PROPOSED REAR EXTENSION AND RELATED WORKS: 3 Lamorna Gardens, Ferring, BN12 5QD

DRAWING: PROPOSED ELEVATIONS

DRAWING No: DS/LAMORNA/05rev3

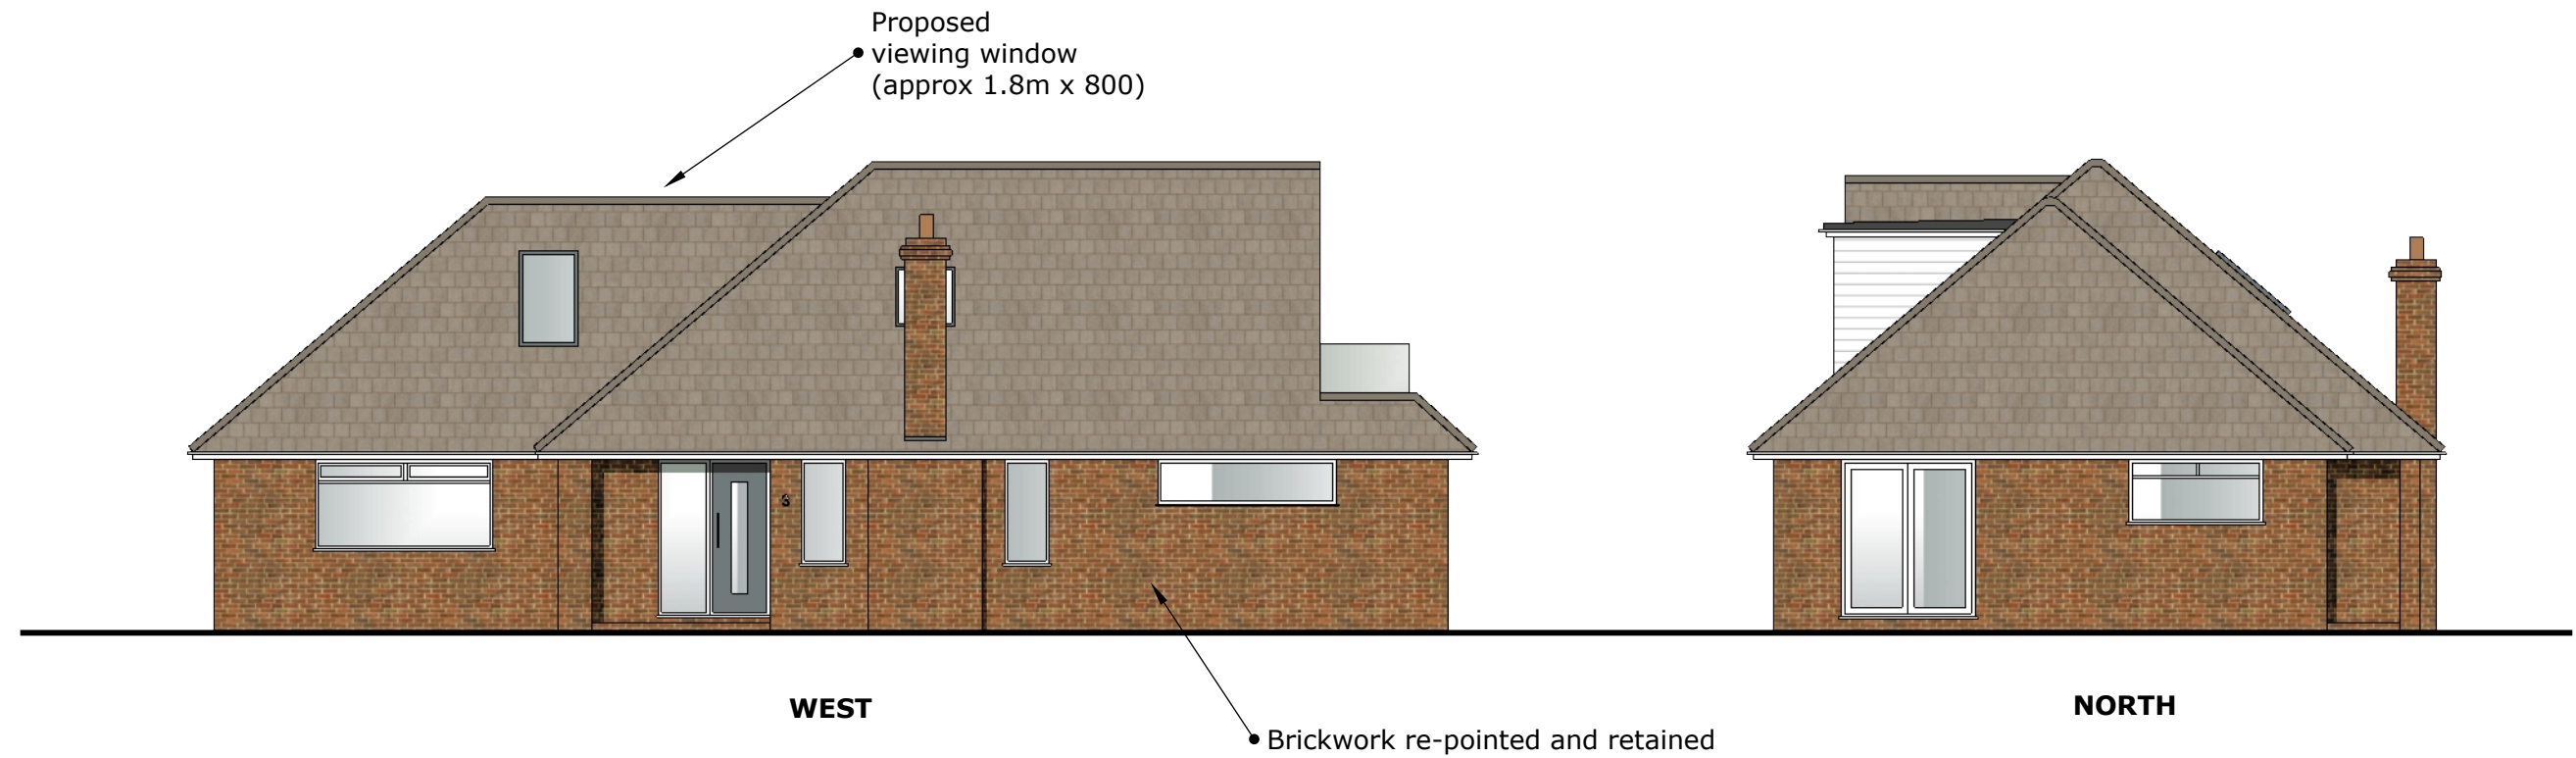
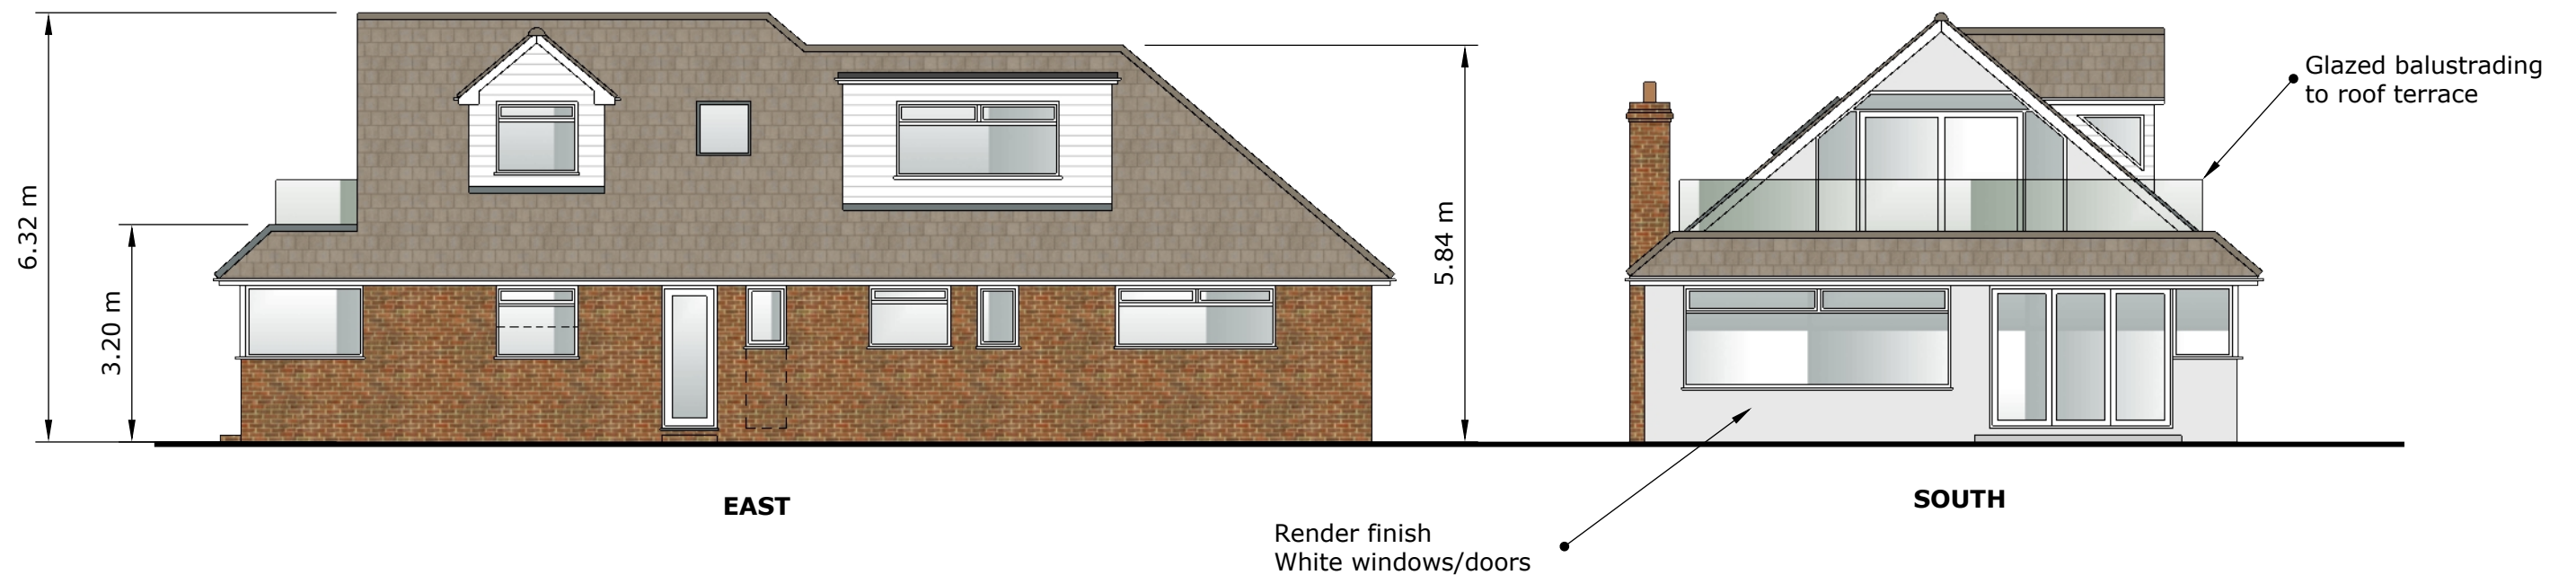
Revised to show second dormer on North elevation
